COMPLIANCE MONITORING PLAN

Former Washington Cold Storage Building
240 15TH Street Southeast
Puyallup, Washington

July 9, 2024

APPENDIX A
ECOLOGY CORRESPONDENCE

FIGURE 3
PLANNED SOURCE
REMOVAL EXCAVATION AREAS
WASHINGTON COLD STORAGE
240 15TH STREET SOUTHEAST
PUYALLUP, WASHINGTON

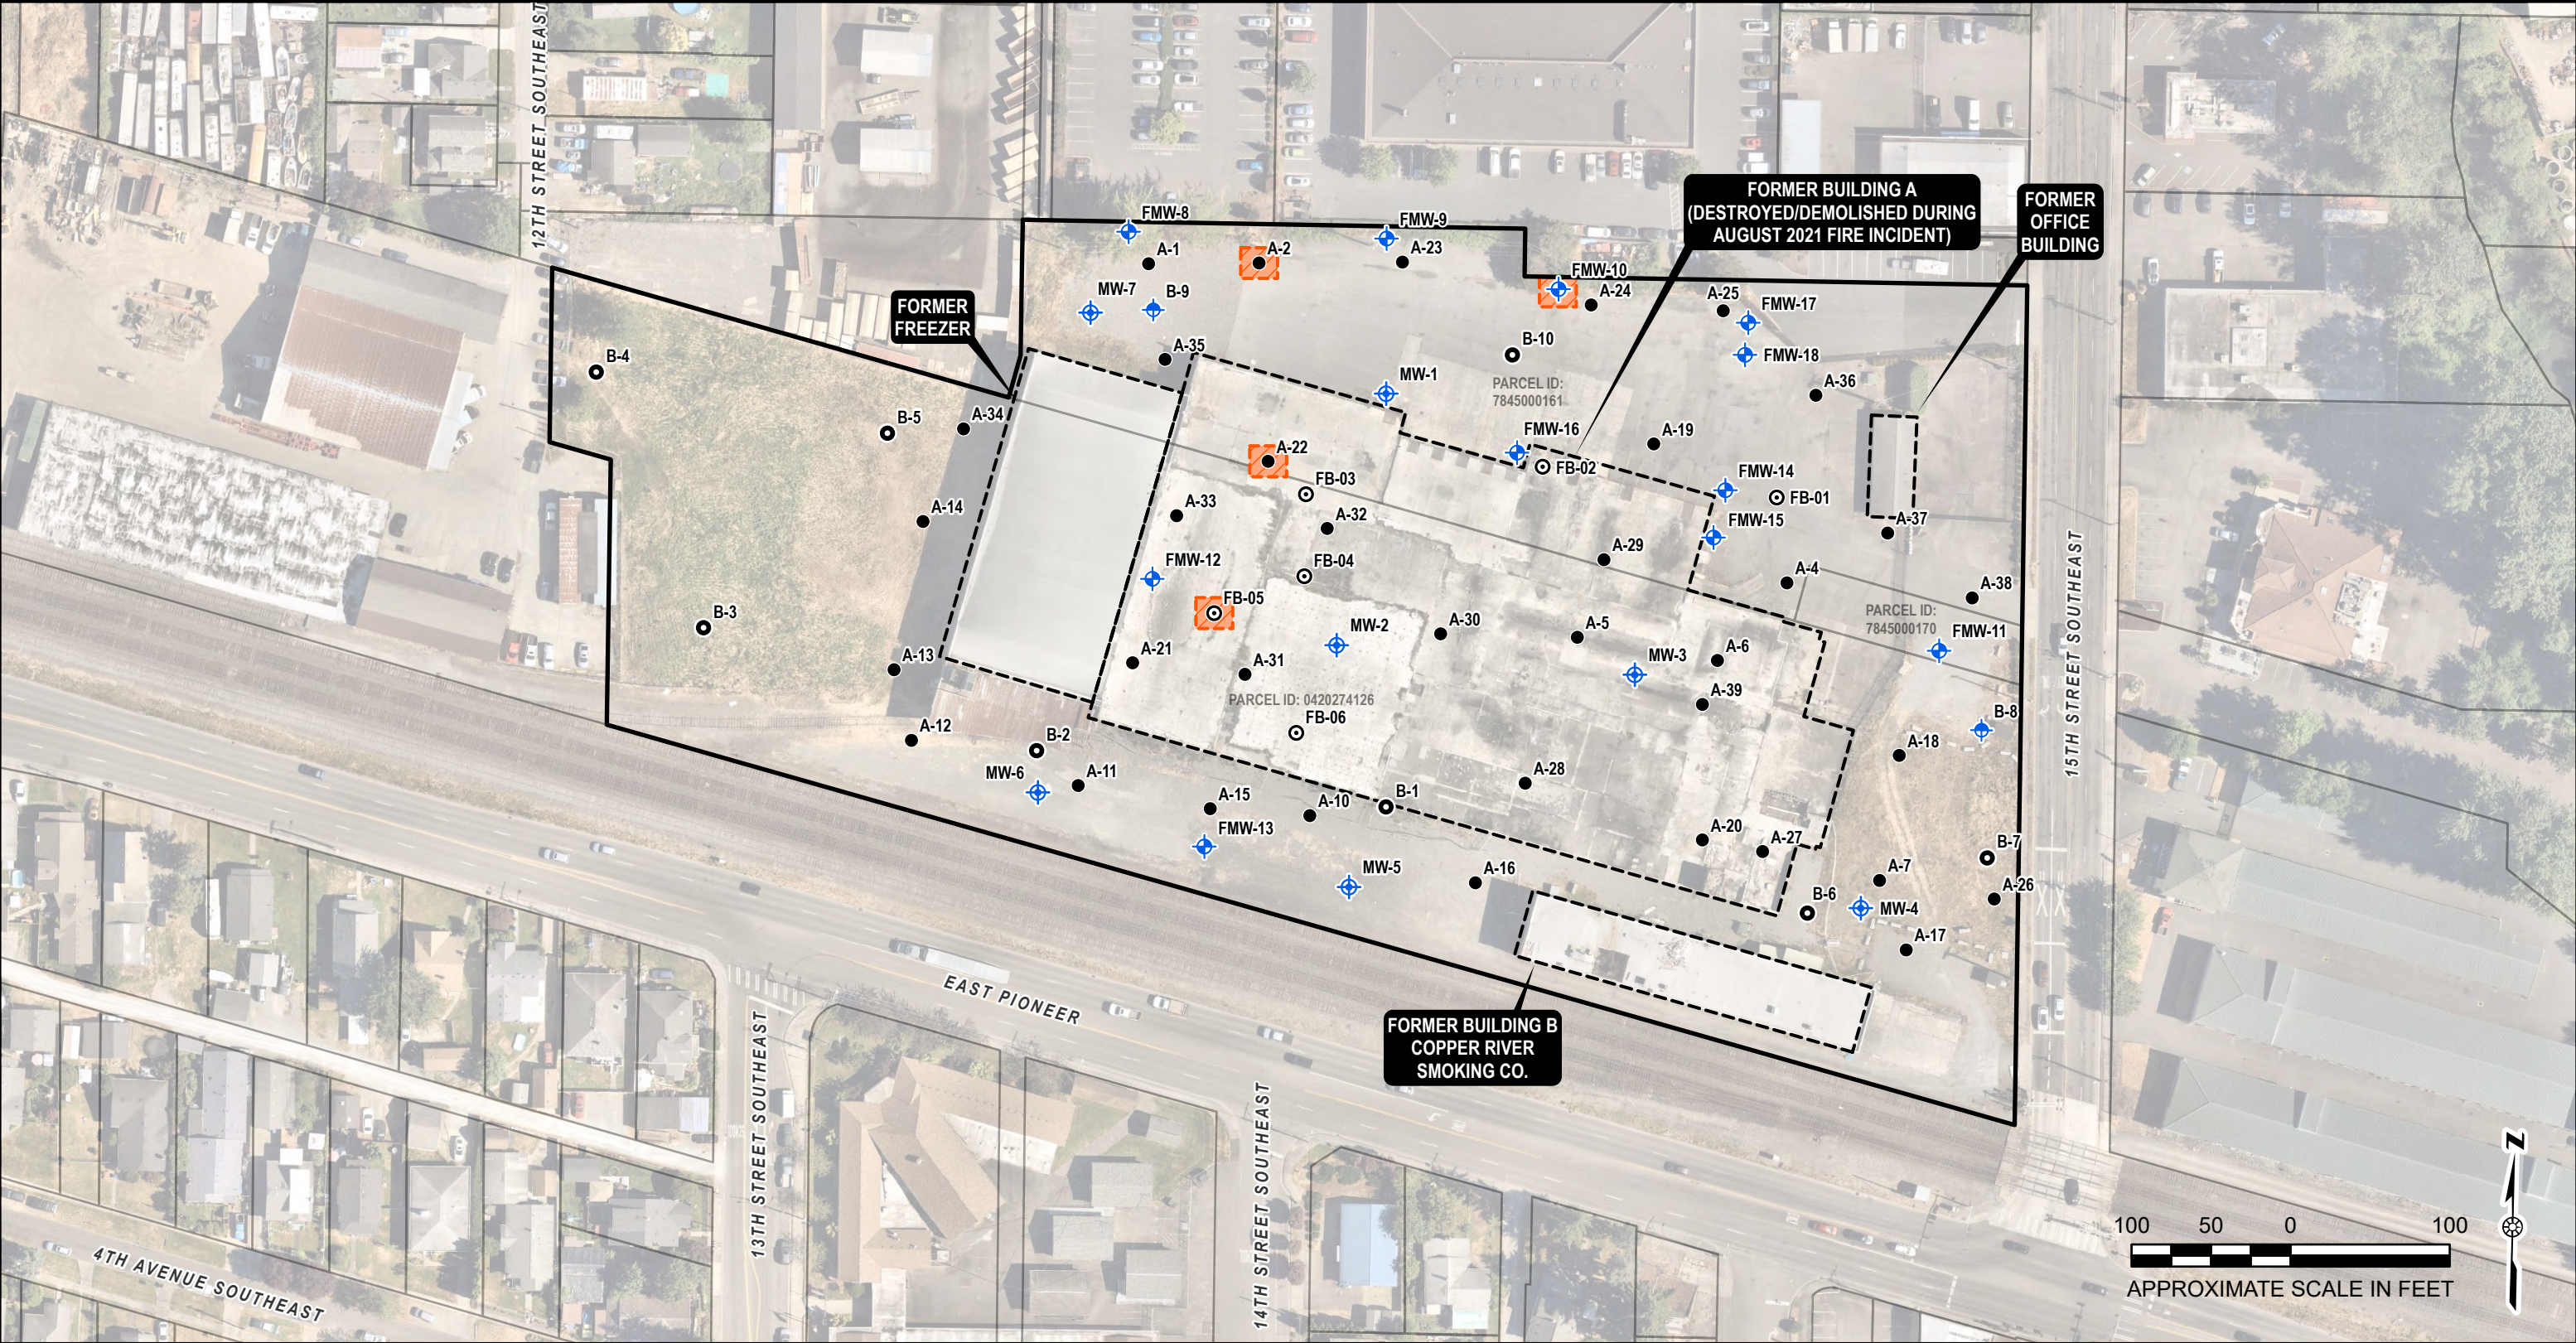
The plan discusses cleanup excavation at locations A2, A22, FB-05, and FMW-10. Exceedances at these locations were as follows:

Location	Depth	Exceedance (mg/kg)	Performance/Confirmation Sample Analysis
A2	0.5 ft	26,100 ORO	NWTPH-Dx
A22	1.0 ft and 8.0 ft	0.0760 and 0.0547 Benzene	BTEX by 8260
FB-05	3.0 ft	0.120 TCE	VOCs by 8260
FMW-10	7.0 ft	0.0832 PCE and 0.0451 TCE	VOCs by 8260
A1	0.5 ft	380 pg/g PFOS	PFAS*

Ecology notes that the exceedance for PFOS at A1 was not included in the list of excavations within the CMP. Ecology recommends conducting an excavation to clean up the soil contamination at this location. Ecology also notes that sidewall samples should be at the midpoint of the sidewall, unless field observations suggest greater potential for contamination at a different depth.

Ecology concurs that performance and confirmation soil sampling at the four excavation areas can focus on the analytes that had exceedances at those locations, unless other observations during excavation (e.g. oily soils or PID readings) suggest additional analytes may be warranted.

Ecology notes that additional locations with soil contamination could be identified during Site regrading work as discussed in Section 2.3 of the CMP. If additional soil contamination is found, Ecology recommends that it be characterized, excavated and disposed offsite, and performance and confirmation soil samples be collected consistent with the CMP.

Ecology notes that the plan indicates additional sidewall sampling for additional 30 feet of sidewall, and additional base samples for additional 900 square feet of bottom. Ecology's Guidance for Remediation of Petroleum Contaminated Sites states:

For larger excavations, try to take additional samples so there is at least one sample every 20 feet horizontally along the sidewalls, and one sample for every 400 square feet of exposed bottom (i.e. each 20 ft X 20 ft bottom area should have at least one soil sample). Multiple samples may need to be taken vertically along the sidewalls in deeper excavations.

Ecology recommends following the guidance for larger excavations for additional sidewall or floor samples.

Ecology understands that no excavation is planned at location A-1. The exceedance for PFOS in soil at this location was based on the soil-protective-of-groundwater concentration, and no PFAS exceedance concerns in groundwater have been identified in this area. Hence, an Empirical Demonstration of a lack of groundwater impacts from soil contamination has apparently been made in this area. In addition, an injection array with PetroFix™ is planned for this area. Therefore, as proposed within the Cleanup Action Plan (CAP) and as supported by further groundwater data collected subsequent to the CAP, Ecology concurs that no excavation cleanup to address PFOS in soil at location A-1 appears to be warranted. We therefore retract our comment requesting excavation at location A-1.

FIGURE 4
REMEDIAL INJECTION
TREATMENT AREAS

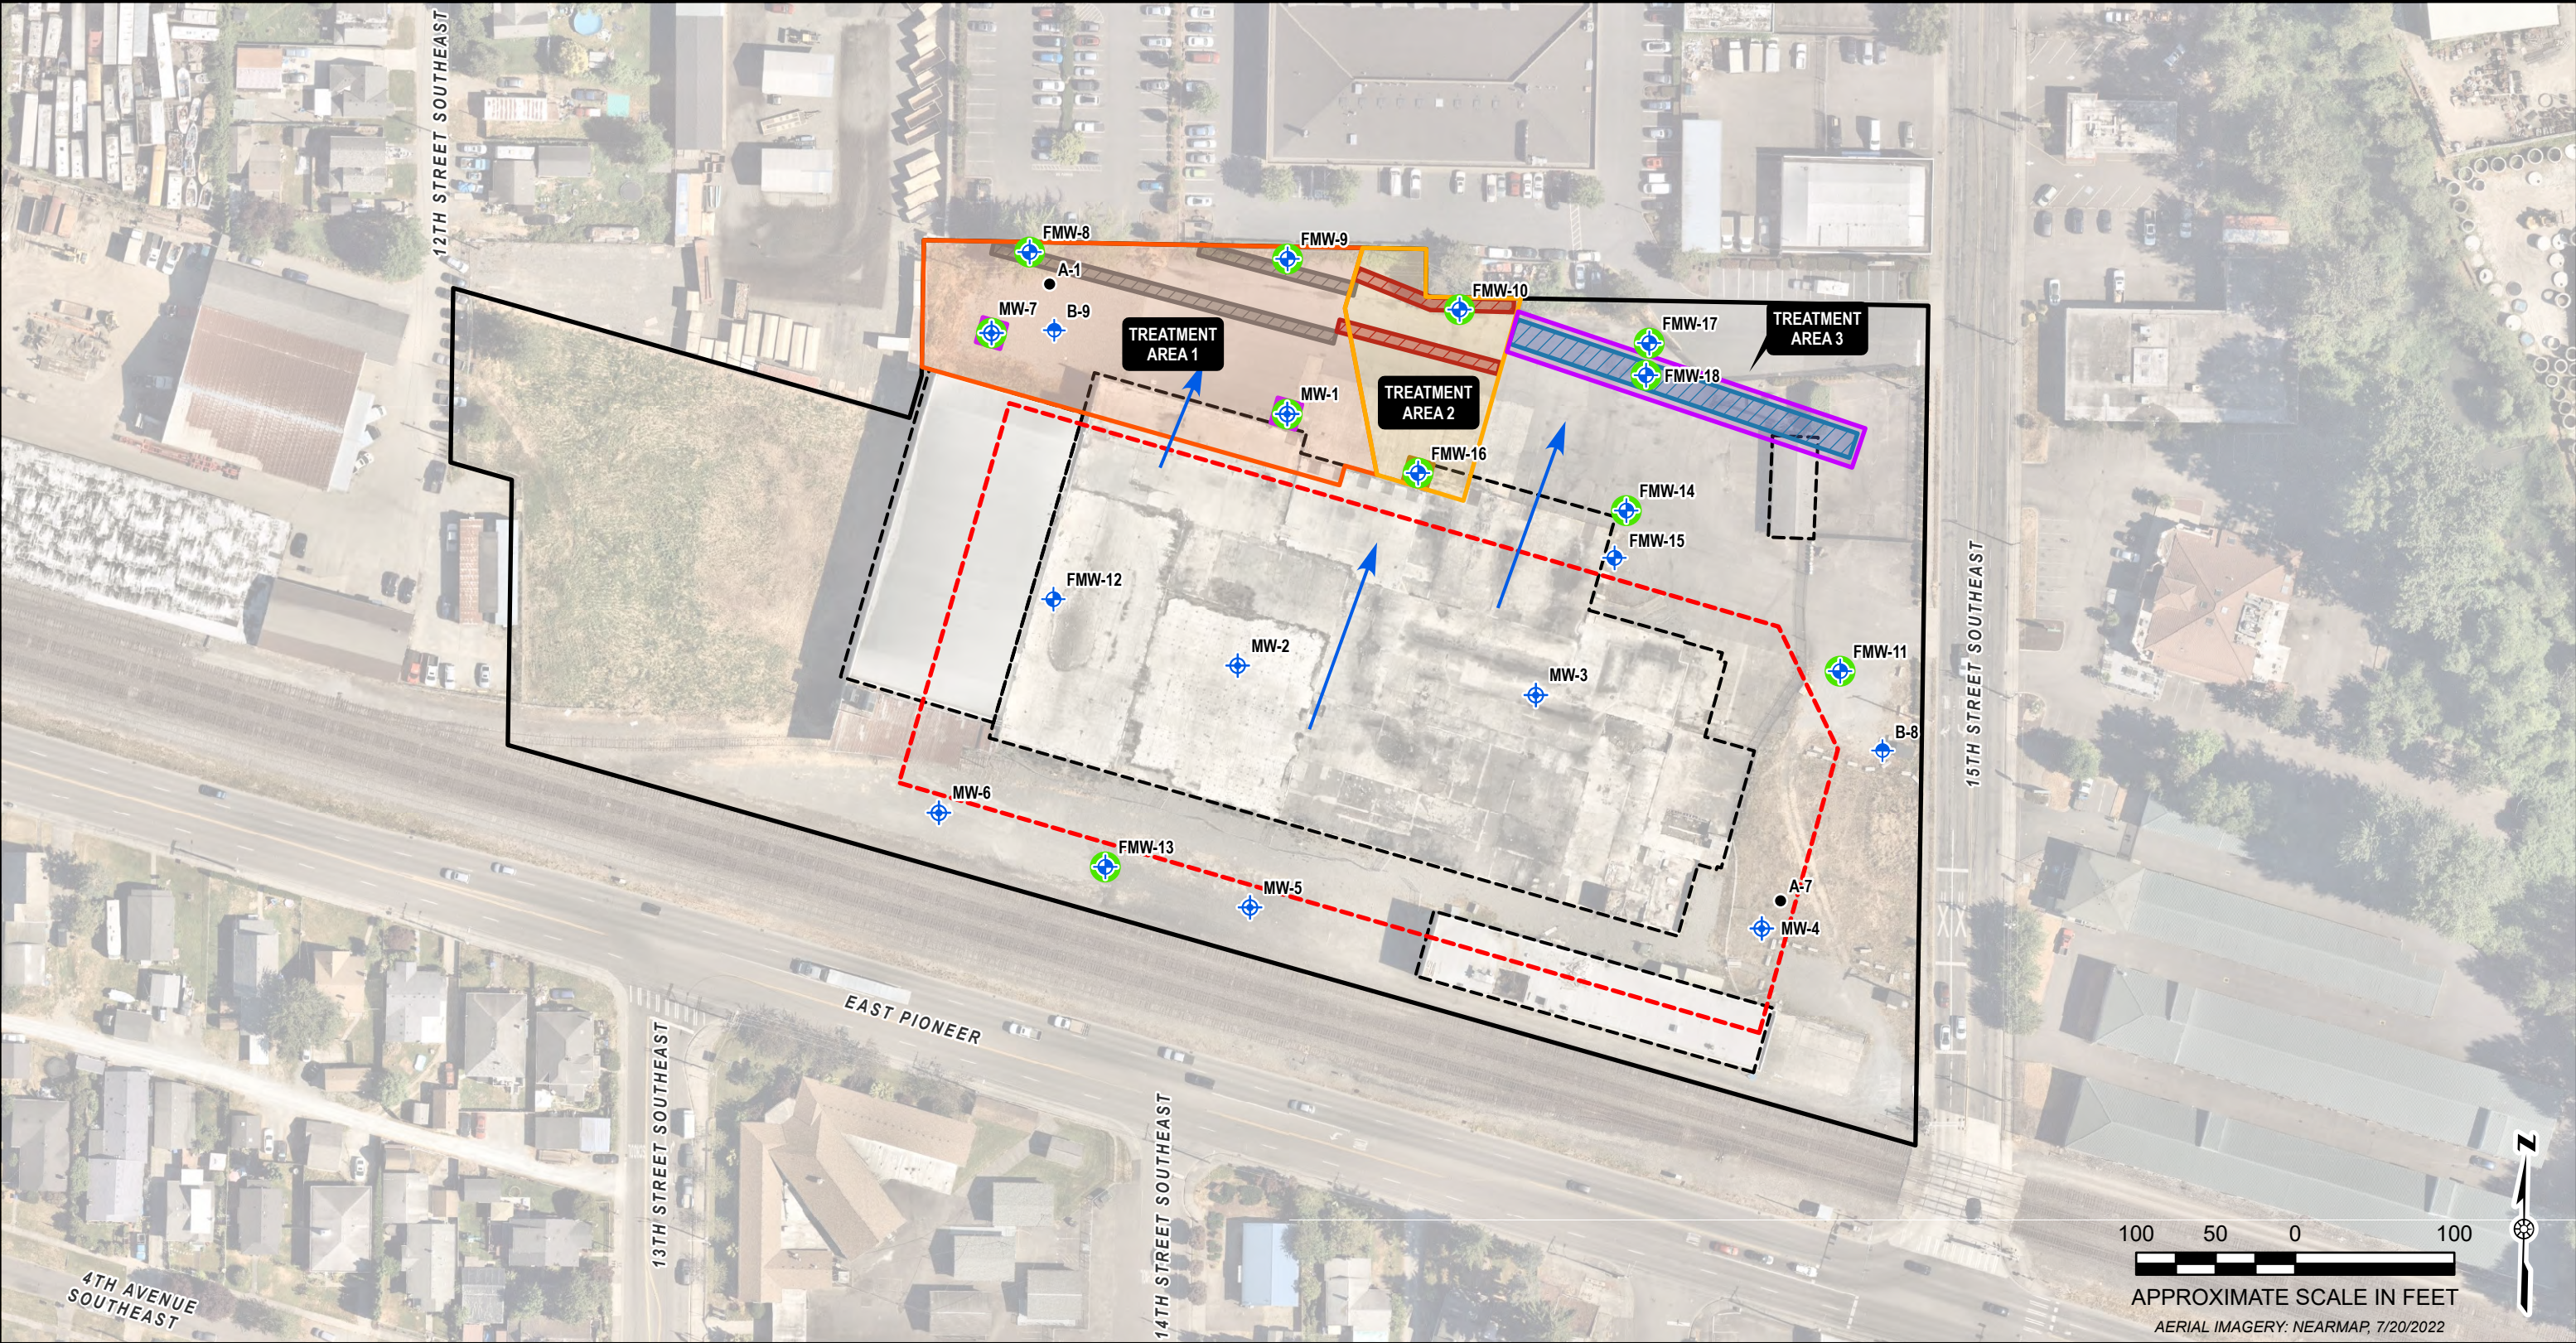
If locations MW-3 and MW-4, where PFAS in groundwater concerns were found, are not continued to be monitored (such as due to planned development constraints), Ecology suggests that remedial injection also take place at both of those monitoring wells to address those specific exceedances prior to decommissioning the monitoring wells. Although such injection would not be expected to have an area-wide impact, they would contribute to the overall strategy for PFAS immobilization at the Site. If those wells can be retained, Ecology suggests that continued monitoring for PFAS in groundwater take place.

Ecology requests the addition of FMW-11 to the compliance monitoring network, since this location is downgradient of MW-4, and since the remedial injection barrier for PFAS in groundwater is located slightly cross gradient from this location. If FMW-11 cannot be retained due to site development constraints, then a new monitoring well located downgradient of FMW-11 would appear to be warranted.

The monitoring wells within the injection areas should be a minimum of half of the distance between injection points. For example, if injection points are spaced 10 feet apart, then the monitoring wells should be a minimum of 5 feet from the closest injection point. Monitoring of appropriate field parameters during injection is suggested at these locations to provide data demonstrating the radius of influence of injection. This comment appears to include FMW-8, FMW-9, FMW-10, and FMW-18, and possibly FMW-17.

Ecology anticipates that the points of compliance will be all monitoring wells that are part of the monitoring network. Because contaminant immobilization (for PFAS) is part of the cleanup approach, it is anticipated that although an expectation of groundwater results below cleanup levels will be used to demonstrate compliance, there could be some remaining contaminated groundwater between the monitoring locations that would be addressed via institutional controls within an environmental covenant (EC).

We anticipate that a minimum of four quarters of groundwater monitoring data with results below cleanup levels at all points of compliance will be needed prior to NFA issue. With respect to the PFAS monitoring, the remedial approach is primarily based on contaminant immobilization, and continued post-NFA monitoring is anticipated. Hence, we suggest that the Area 3 (PFAS) monitoring language be adjusted such that monitoring will be done on an annual basis until NFA is issued, and a 15 month frequency for 5 years is anticipated following NFA issue (with the need for continued monitoring to be determined by Ecology's periodic reviewer).

For upgradient monitoring well location FMW-13, an annual monitoring basis is suggested prior to NFA issue. The need for continued post-NFA monitoring at specific locations can be determined within Ecology's NFA opinion letter, when issued.

Ecology suggests that all monitoring wells that can be preserved be retained for continued water level measurements. Water level measurements should be taken on a quarterly basis until NFA issue, and potentiometric surface maps prepared from the data. If there are monitoring wells that must be decommissioned due to site development activities, this should be done by a licensed well driller and Ecology Toxics Cleanup Program (TCP) should be notified of such.
